ODOT ADA Curb Ramp Inspection Questions

Effective Date: Jan. 2020 – June 2020

This document was created in an effort to answer questions brought up during the Oregon Department of Transportation's ADA Curb Ramp Inspection Training course (January 2020 – March 2020). Questions were gathered and documented during class and via email. These questions were then answered by members of the ADA Standards Team located in the Technical Leadership Center. This document is intended to serve as supplemental material for the training course to assist in filling gaps within the material and to mitigate confusion. This document is organized by sections (outlined in the Table of Contents) and each section is numbered independently of previous or subsequent sections. This numbering scheme will allow for periodic updates without compromising the overall organization of the document.

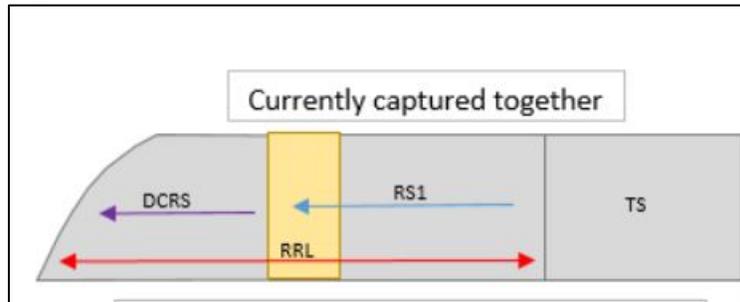
(3) How is the Ramp Run Length captured when you have a Directional Curb?

The length of the ramp run 1 and the directional curb are one length captured together as shown below by the dimension ramp run length (RRL). The turn space/landing length dimension is captured in the other parts of the form. [TS= turn space, RS1= ramp slope 1, DCRS= directional curb running slope]

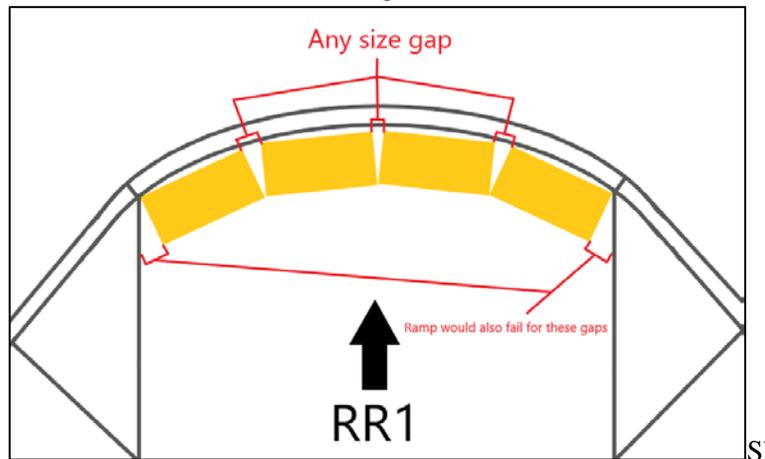
(1) A photo in the training presentation (below) shows the detectable warning surface cut to fit the curve of the curb, is this an acceptable practice?

No. A continuous section of detectable warning surface that is 2 feet deep in the direction of the pedestrian travel for the entire curb ramp width is required. The placement location of the detectable warning surface is dependent on the curb ramp style and/or on the distance between the grade break to the back of curb (see applicable ODOT standard drawings).

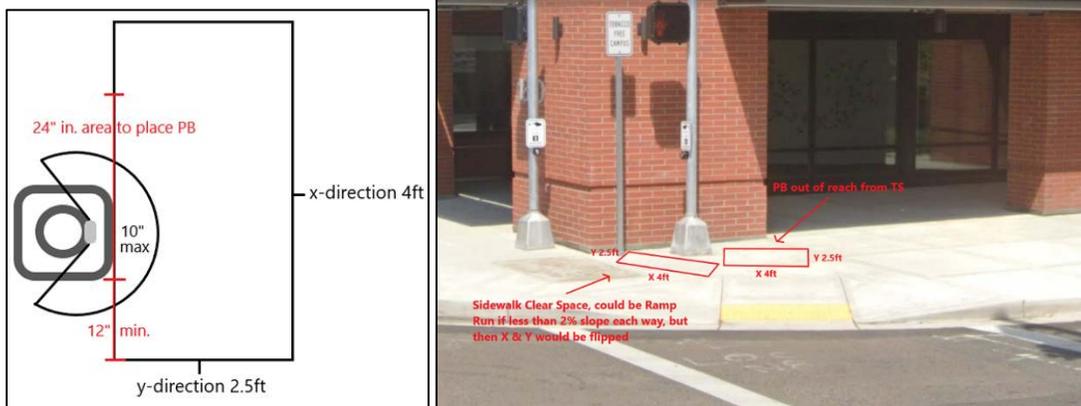
(2) Does the push button need to be exactly parallel with the paired crossing? Can the push button clear space be skewed in relation to the pedestrian pole?

The push button placard, and tactile arrow must be parallel with the paired crossing. This provides direction cues to pedestrians with low vision or who are blind. There is no formal measurement.

The maximum reach cannot exceed the 0.83 FT maximum distance from any angle, the pedestrian may have to press the button straight out, to the side, or by pushing toward the front of the pole. These are both acceptable.

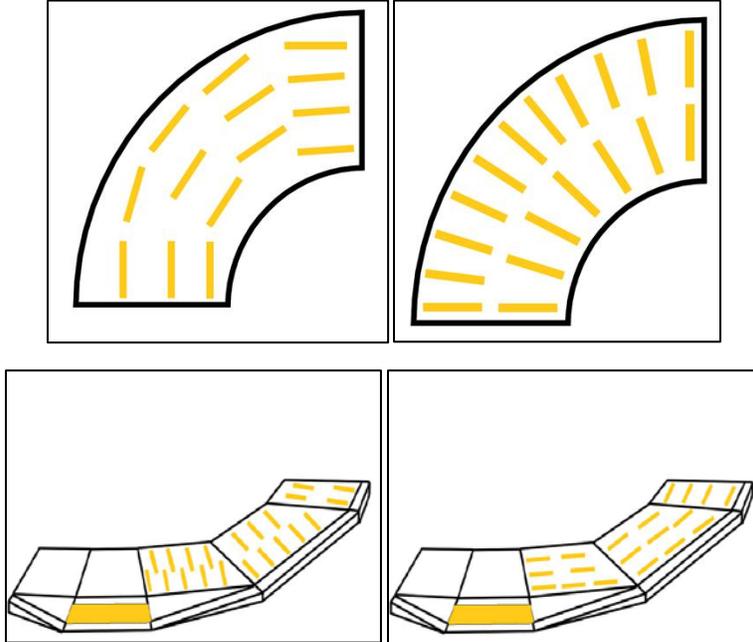
- (3) **Can End-of-Walks have a landing at the top of the ramp?**

ODOT's standard is a level area (landing) at the bottom of the ramp. Parallel curb ramps have a running slope 1 that is in-line with the direction of sidewalk travel and ramps down to a level turning space where the pedestrian can change directions and continue down the roadway. Site specific constraints may require designs which include a landing at the top of the ramp run 1 and site specific situations would need to be evaluated on a case by case basis; however a 4.0ft x 4.0ft clear space at the bottom would still be needed.
